Development Application: 87 Lower Fort Street, Millers Point - D/2024/179

File No.: D/2024/179

Summary

Figure 15: Excerpt of the submitted height plane analysis

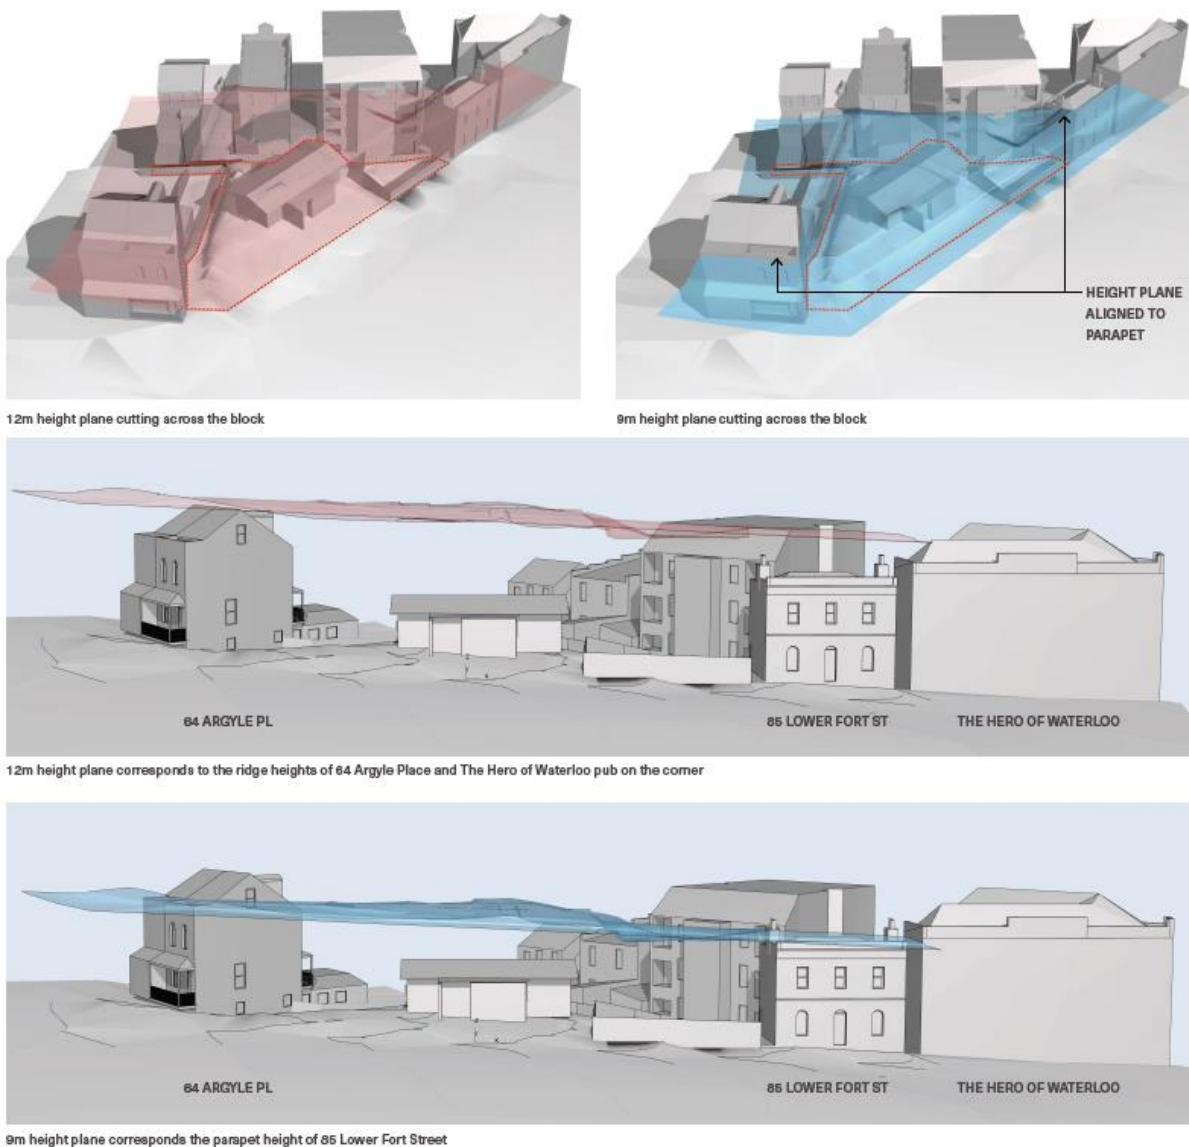
- (iii) The proposed height has been identified as a result of a comprehensive urban design and height plane analysis. This analysis confirmed that a maximum height between 9m-12m is compatible with the existing characteristics of parapet and roof designs in the area. Excerpts from the height plane analysis are provided in Figure 15 below.

52. The applicant has identified the existing character of the area by undertaking a height plane analysis and determining the most appropriate and sympathetic height to respond to the heritage context as shown above in Figure 15. It should be noted that whilst the numeric variation is significant, this is a result from the unique height control standard that applies to Millers Point. The control was formulated to map the height of existing buildings, noting that the majority of buildings within this precinct are state and locally listed heritage items and are generally two to four storeys in height. The subject site is somewhat of an anomaly in Millers Point where the detracting building height would not result in an appropriate built form for new development on the site. In this unique set of circumstances, a variation of the height control of this extent would not set an undesirable precedent.
